To: Paul Glasgow and Victoria Simonsen, Town of Lyons

From: Robert Brakenridge

Date: February 21, 2020

I am concerned that the Summit-sponsored Drainage Report does not address the recommendations of the town's Stormwater Master Plan. As far as I could tell, it does not reference it at all. It is thus not clear that the authors (Scott, Cox, and Associates) reviewed the Stormwater Plan, which made some very specific recommendations and included maps for the area that the new housing and roads are to be constructed in.

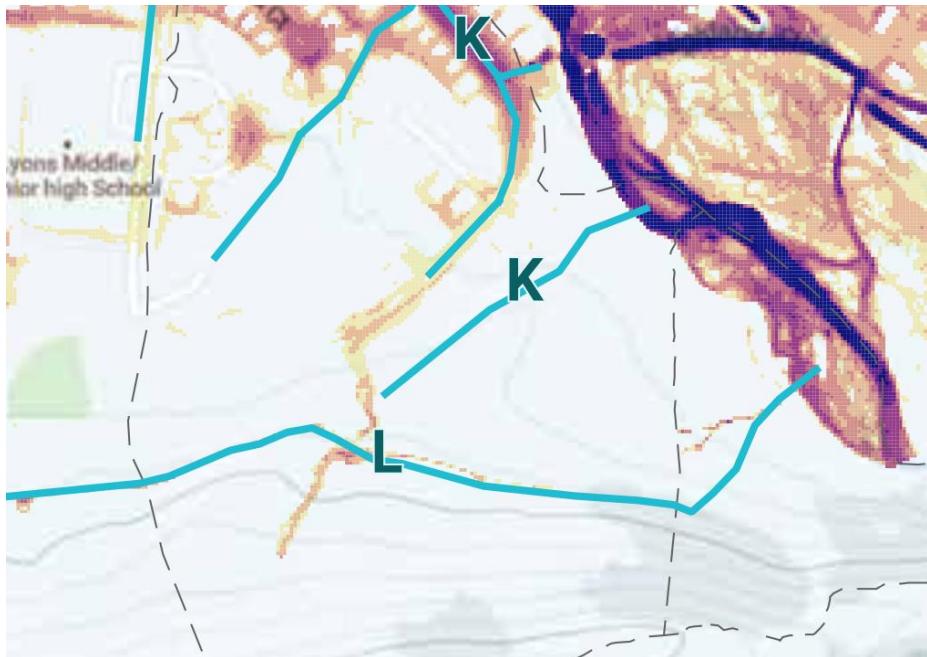
page 40 "Flooding hazards in the Lyons Valley Park watershed are the result of development within the basin without adequate storm drain conveyance. The 18 inch storm drain throughout the upper reaches of the development was not designed to convey major storm events."

page 41 "The storm drain infrastructure installed with the development of Lyons Valley Park subdivision is a minor drainage system and lacks capacity to convey major storm events. This alternative proposes to increase the storm drain along the eastern alignment to convey the design flow for the 100 year storm."

page 42 "The South Ledge Ditch located south of Lyons Valley Park Subdivision intercepts runoff from the subwatershed. Formalizing the Ditch to convey stormwater east towards St Vrain Creek would reduce the tributary area contributing to the flooding hazards of Lyons Valley Park Subdivision. This alternative should be developed in coordination with the future development of Lyons Valley. A drainage feature around the south end of the currently platted lots would benefit the new construction as well as the existing homes in the neighborhood." ...

and... "Breaches and overtopping of the existing (South Ledge) ditch are likely to continue to occur given the earthen embankment construction of the ditch. As the platted future development moves into the final plan approval process, careful coordination should identify the benefits to both existing and future homes in the area. And, when the cost of perimeter surface water conveyance (i.e. swale) is compared to sizing interior storm inlets and pipes sized to safely capture and convey the offsite flows, the cost-benefit should resolve any further limitations of the concept."

The authors of our Stormwater Plan proposed to route excess runoff per the graphic below (blue lines):

These alternative solutions, listed in the Plan, have the effect of both protecting the proposed new development along Carter Drive and Tract A, and also the existing homes in this portion of Lyons Valley Park.

I have not carefully examined yet the engineering plans for Lyons Valley Townhomes, but believe the engineering and drainage features must already be accommodating the planned final grading and expected local runoff. That local runoff is only a small part of the issue, however. Instead, the Stormwater Master Plan, as noted, indicates that the existing 18 in storm sewer along parts of McConnell Drive is undersized. The new development will make this situation worse. Meanwhile, directly above the Townhomes, is a tall ridge and also a drainage, that drops down onto McConnell Drive and thence eastward along the street. Even without failure of the Ditch, the potential for flood damage is high (see route of that floodwater shown in the middle of the figure above).
